COLE'S ADDITION TO KINGSWOOD SUBDIVISION, RESUBDIVISION OF LOTS 3 & 4

APPLICATION NUMBER 15 DATE July 10, 2008
Coles Addition to Kingswood Subdivision, Resubdivision of
APPLICANT Lots 3 & 4
REQUEST Subdivision

DETAIL SITE PLAN

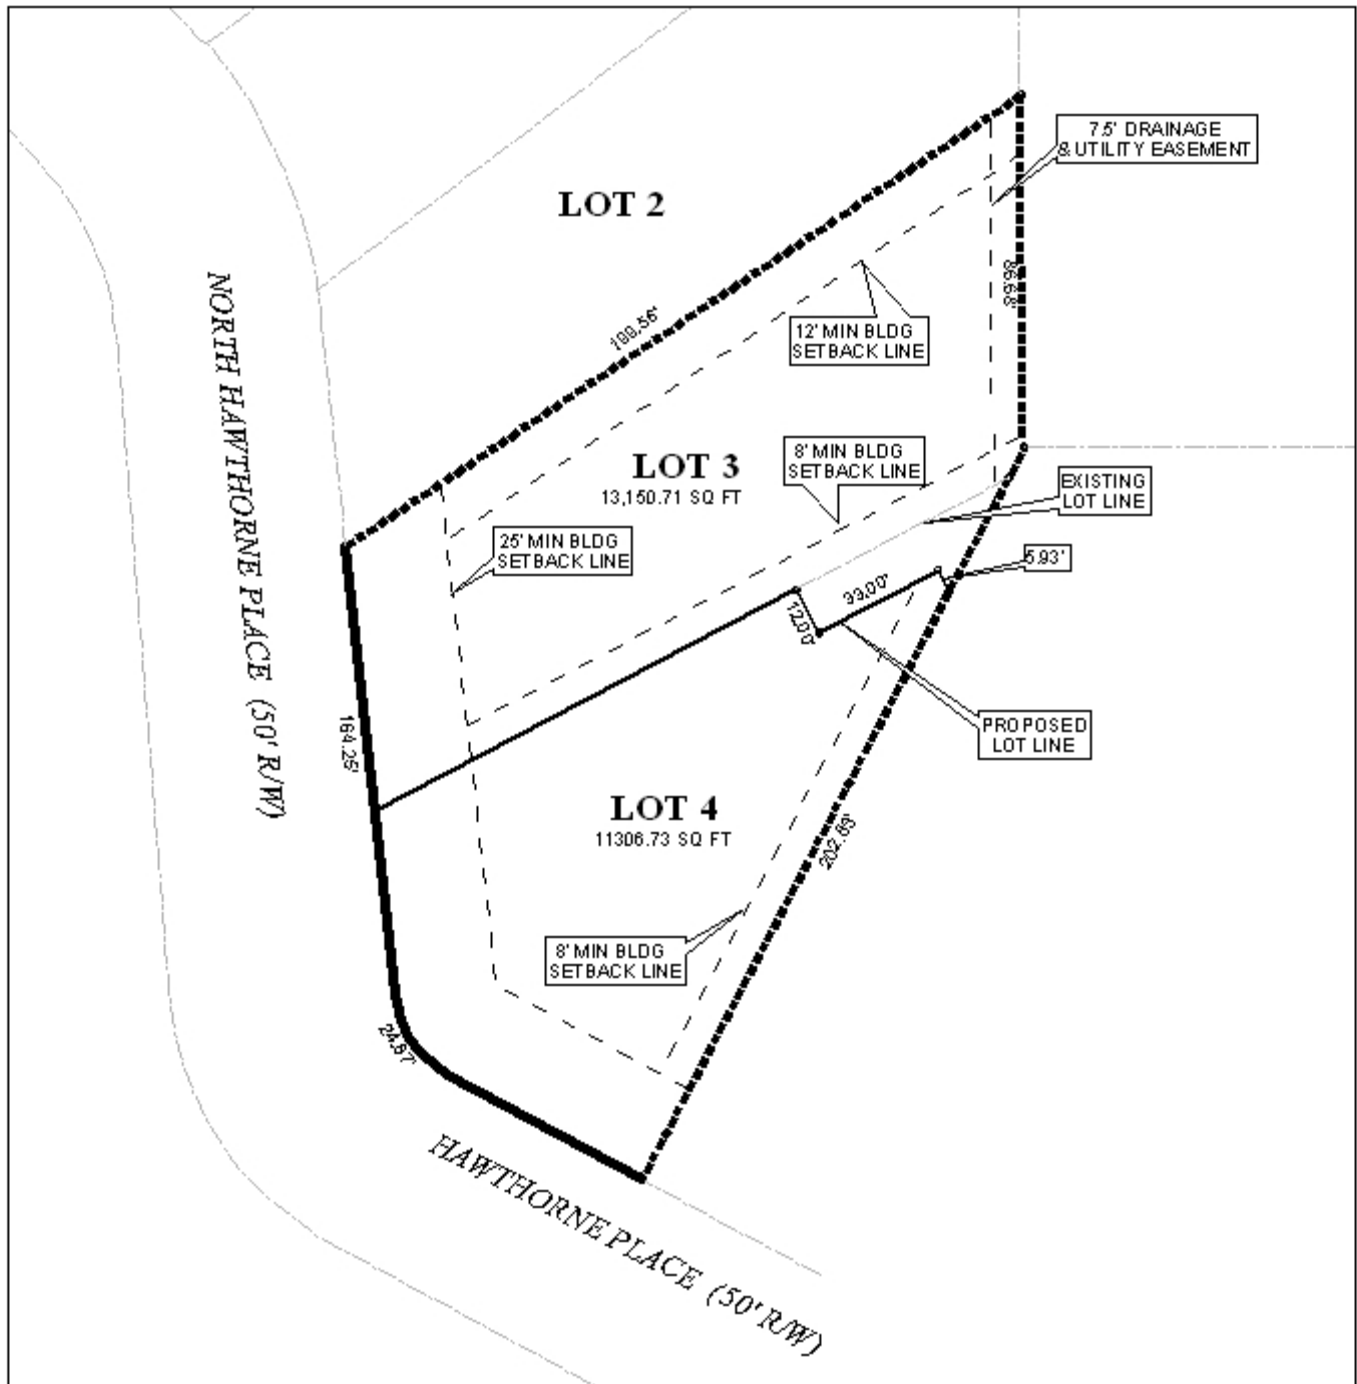
The site fronts Hawthorne Place and Hawthorne Place North, both with sufficient right-of-way. No right-of-way dedication is required. As a means of access management, a note should be placed on the final plat stating that each lot is limited to one curb cut, with the size, location, and design to be approved by Traffic Engineering and conform to AASHTO standards.

One concern of the previous subdivision was that there might not be suitable buildable area on the lots, but staff was satisfied that such could be provided. Lot 3 is already developed, but Lot 4 is still vacant. In this instance, Lot 4 would lose area, but a review of the evidence supporting adequate buildable area furnished with the original subdivision indicates that Lot 4 would still contain sufficient buildable area. As originally recorded, the lots have a 12' left side and an 8' right side yard setback. The plat submitted indicates these setbacks on Lot 3, as originally recorded, but only the 8' right side yard setback for Lot 4 is indicated. Therefore, the plat should be revised to indicate the 8' right side yard setback on Lot 3 following the revised lot line, and the 12' left side yard setback on Lot 4 following the revised lot line should also be indicated.

The lots are labeled with their sizes in square feet as originally recorded. The size labels should be revised to indicate the revised area for each lot, or a table should be provided on the final plat depicting the same information.

- 1) placement of a note on the final plat stating that each lot is limited to one curb cut, with the size, location, and design to be approved by Traffic Engineering and conform to AASHTO standards;

- 2) revision of the plat to indicate the 8' right side yard setback on Lot 3 following the revised lot line;
- 3) revision of the plat to indicate the 12' left side yard setback on Lot 4 following the revised lot line;

- 4) revision of the plat to label each lot with its revised area in square feet, or the provision of a table on the final plat depicting the same information;
